AERO ADVENTURE AVIATION, INC

SAFETY DIRECTIVE AV II – 0001

INSPECTION AND/OR MODIFICATION OF CONTROL TUBE THREADED INSERT ATTACHMENT

Figure 1

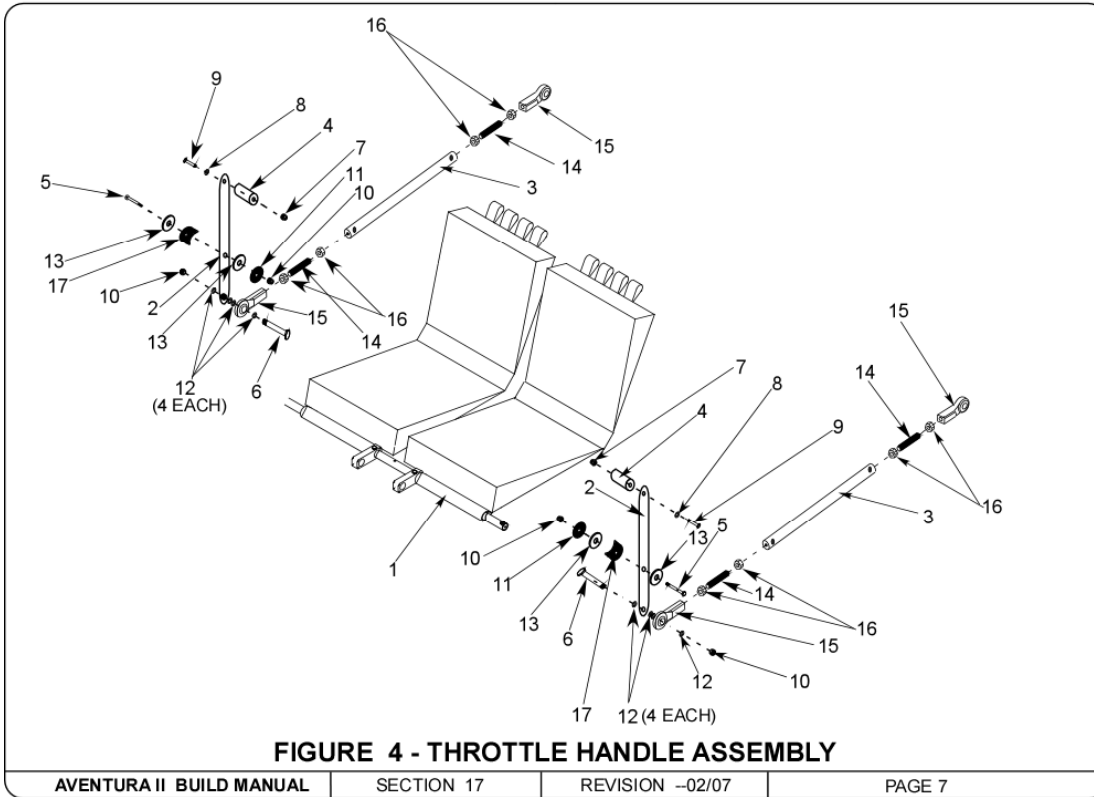
Inspect the Left and Right Dual Throttle Control Tubes (see Fig. 1, part 3) to ensure that the Threaded Inserts are secured to the tube with a solid rivet or an AN3 Bolt and Nut (see Fig. 3).

2.2.1) Any control tube inspected IAW (2.1.1, 2.1.2 and 2.1.3) where the Threaded Insert is not secured with a solid rivet or an AN3 Bolt and Nut must be removed, modified and reinstalled by an authorized mechanic or repairman. Modification will include the installation of a solid rivet or an AN3 Bolt and Nut at each Threaded Insert connection.

Figure 2

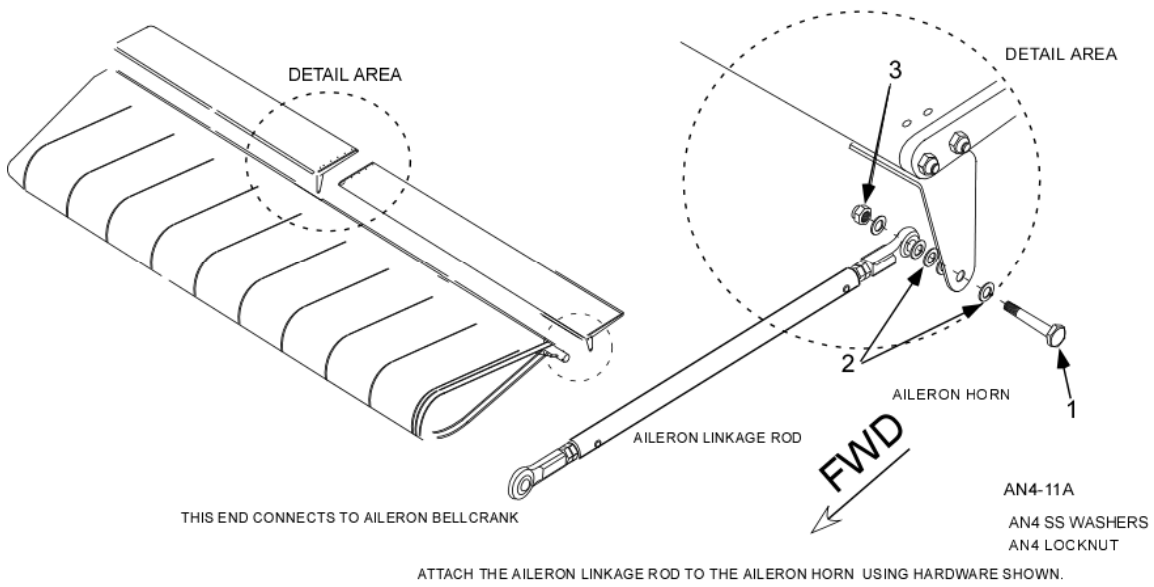
Inspect the Left and Right Aileron Control Tubes (see Fig. 2, Aileron Linkage Rod) to ensure that the Threaded Inserts are secured to the tube with a solid rivet or an AN3 Bolt and Nut (see Fig. 3).

Figure 3

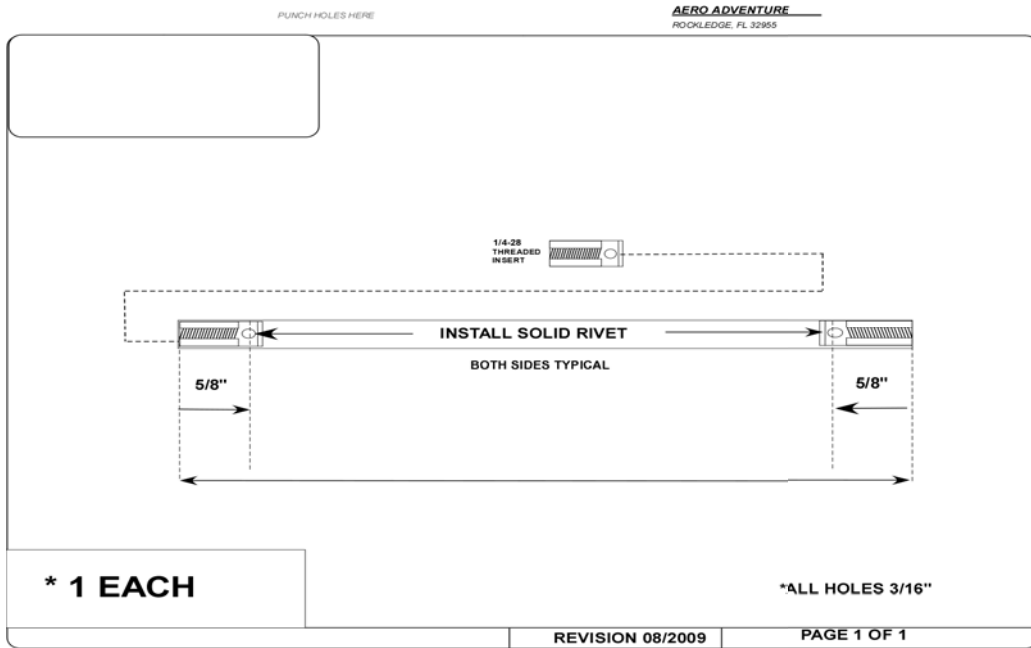
Field experience has shown that connection of the ¼ - 28 threaded insert (see Fig. 3) on certain control tubes require modification due to the following: Threaded Insert can separate from the control tube.

Figure 4

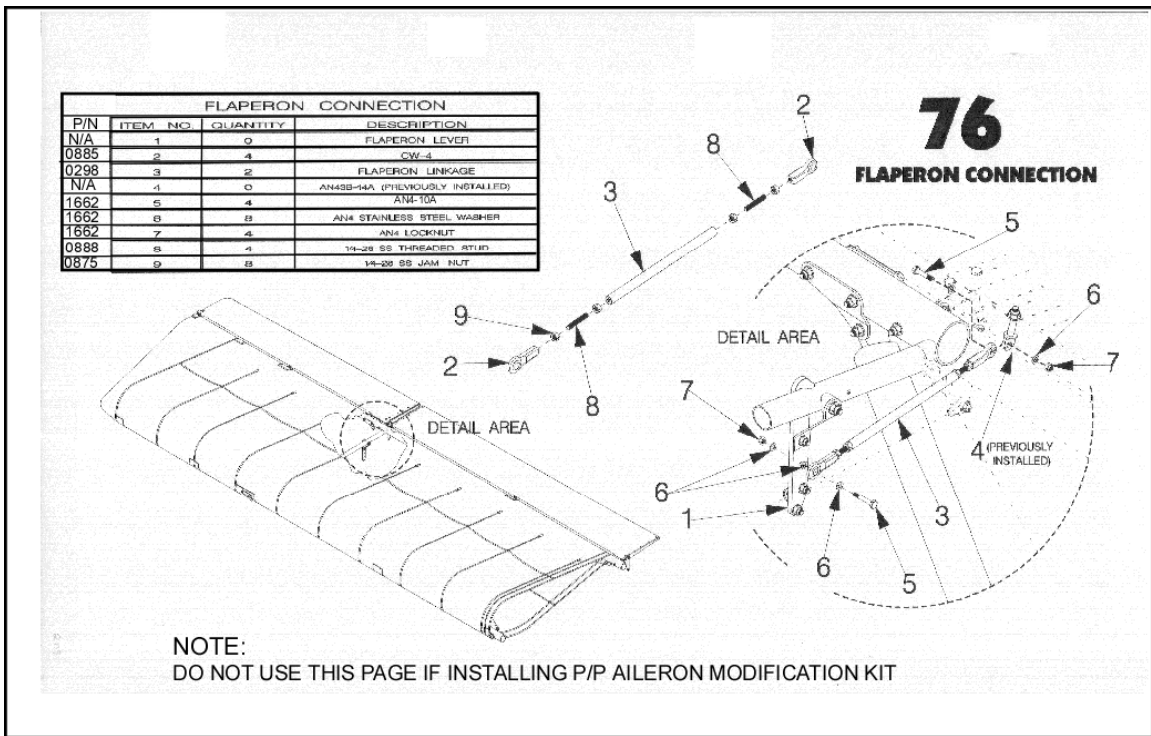
Inspect the Left and Right Flaperon Linkage Control Tubes (see Fig. 4, part 3) to ensure that the Threaded Inserts are secured to the tube with a solid rivet or an AN3 Bolt and Nut (see Fig. 3).
